Our ref: EDOCS 17724205

Department of
**Regional Development,
Manufacturing and Water**

24 January 2023

**Request for advice on groundwater matters relating to Arrow (Hopelands)
Environmental Authority amendment application**

Maximum travel distances for the development case for each model utilised in the uncertainty analysis (Arrow).

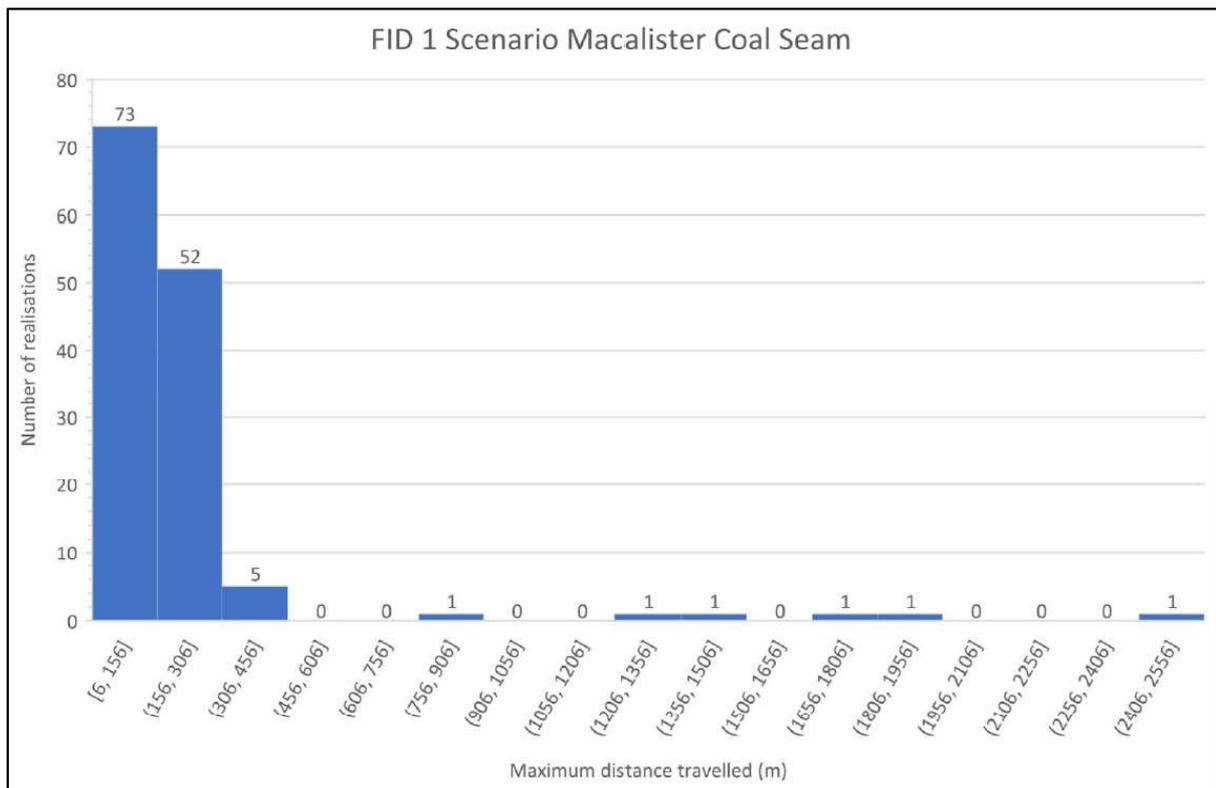
- 1.8. The reported uncertainty analysis does not allow for a thorough analysis of the probability of a small number of particles travelling a longer distance. Upon request from OGIA, Arrow subsequently provided the maximum travel distances for the development case for each model utilised in the uncertainty analysis (see *Attachment 1*). This provides sufficient evidence to conclude that contaminant particles are likely to remain within a few hundred metres of the source.
